## EZ Hauler 3500/3800 Product Announcement

**Subject:** Outrigger Hub & Pin Update

**Announcement:** CCG1741

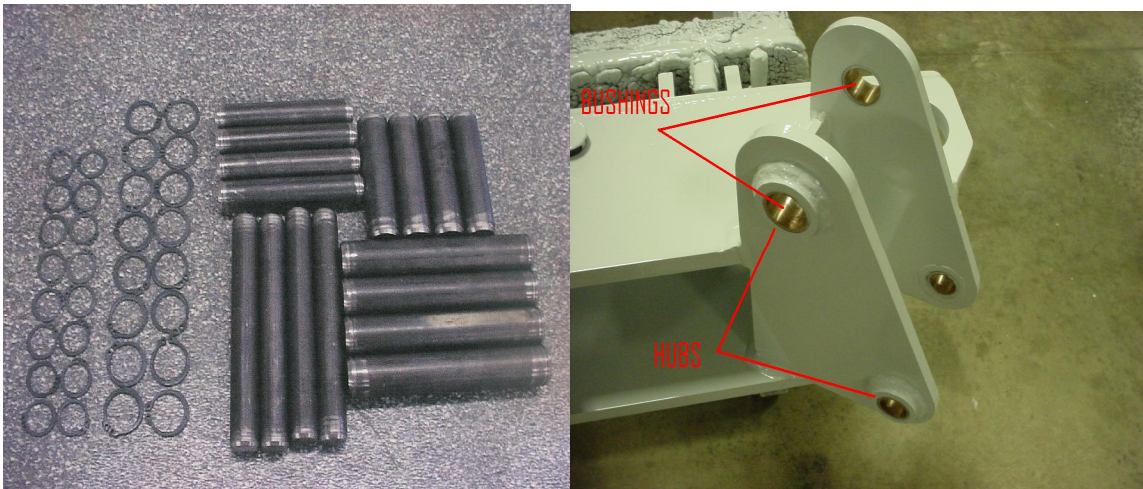
**EZ Hauler models 3500/3800 manufactured prior to June 1, 2006 may experience hydraulic outrigger structural damage when overloaded. Failure to update could result in total outrigger failure!**

**This mandatory update does include that all pins are changed over from the “tear drop pin head w/bolt” style to the snap-ring retention pins. To install this update you will need the hydraulic outrigger pin & bushing kit, that is part number 011008-0331. You will also need the outrigger hub kit, that is part number 031108-0950. The hubs will need welded on, so have a qualified welder do this work.**
